P 514927

SEWAGE DISPOSAL SYSTEM
HOWARD COUNTY HEALTH DEPARTMENT
BUREAU OF ENVIRONMENTAL HEALTH
410-313-2640

UBDIVISION Paternal Gift Farm LOT NUMBER 13 ADDRESS 13505 Paternal Gift Drive

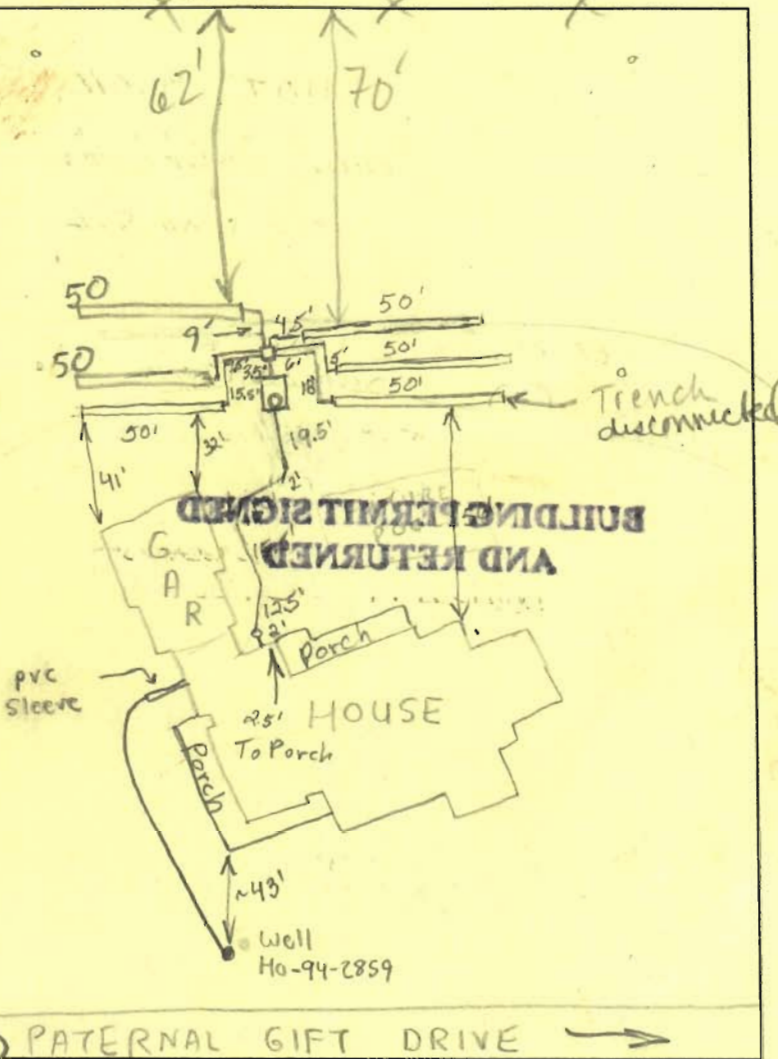
PRE-CONSTRUCTION INSPECTION: 4/20/01 - MET INSTALLER AT SITE, EASEMENT STAKED, SOME FILL PLACED IN TOP PART OF SEPTIC AREA WILL PREVENT THE APPROPRIATE SETTING OF A TANK AND USE OF TOP PART OF SEPTIC EASEMENT, BUILDER NOTIFIED THAT JOB IS SHUT DOWN UNTIL FILL REMOVED, ALLOWED 1' OF EXTRA COVER ON TOP OF ST AFTER FINAL GRADING (FOR A TOTAL OF 4')
 INSPECTION COMMENTS: BUILDER ACKNOWLEDGES THIS - (SRK)

5/30/01 - MET CONTRACTOR & BUILDER, BUILDER WILL MOVE FILL OUT OF ^{TOP OF} EASEMENT CONTRACTOR TO SET S.T. SLIGHTLY IN A PORTION OF THE TOP CENTER OF SDA, TRENCHES TO BE RUN ON CONTOUR IN BOTH DIRECTIONS, OR TO WRAP SOME TRENCHES AROUND S.T. (MAINTAIN 5' FROM ST TO TRENCHES) IF NECESSARY, NO MORE THAN 4' OF COVER ON TOP OF S.T., STOP WORK ORDER LIFTED - (SRK)

5/30/02 Trench disconn. with glued PVC CAP ONTO 4" stub. 2nd trench $\geq 20'$ from pool (K)

Approved Septic System Plan
Howard County Health Department

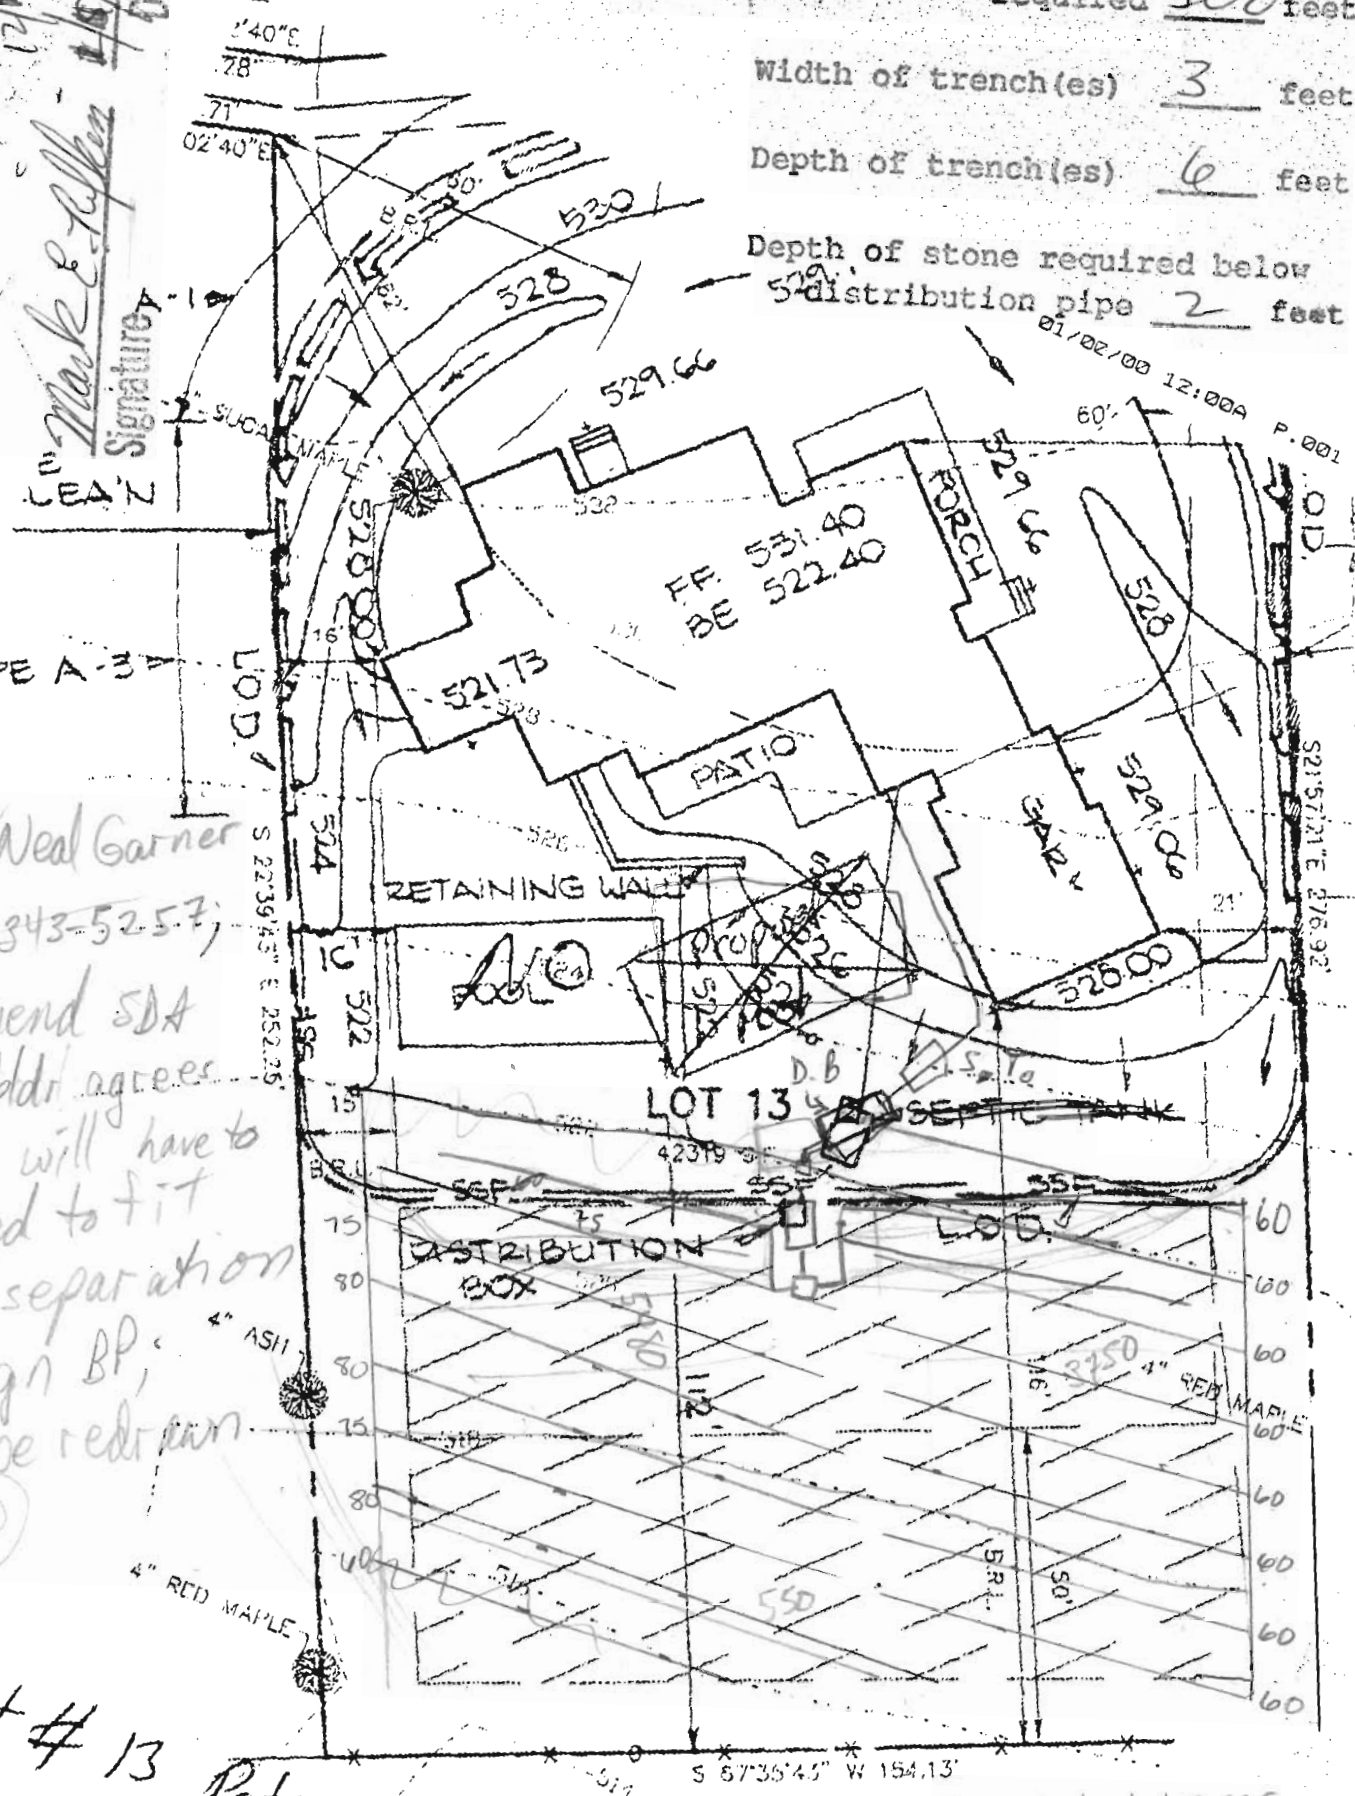
12/7/00
T/c w/ Neal Garner
Bldr 301-343-5257;
OK to amend SDA
as shown; bldr agrees
that pool will have to
be adjusted to fit
for 20' separation
OK to sign BP;
plan to be redrawn.

930 total linear ft of trench shown
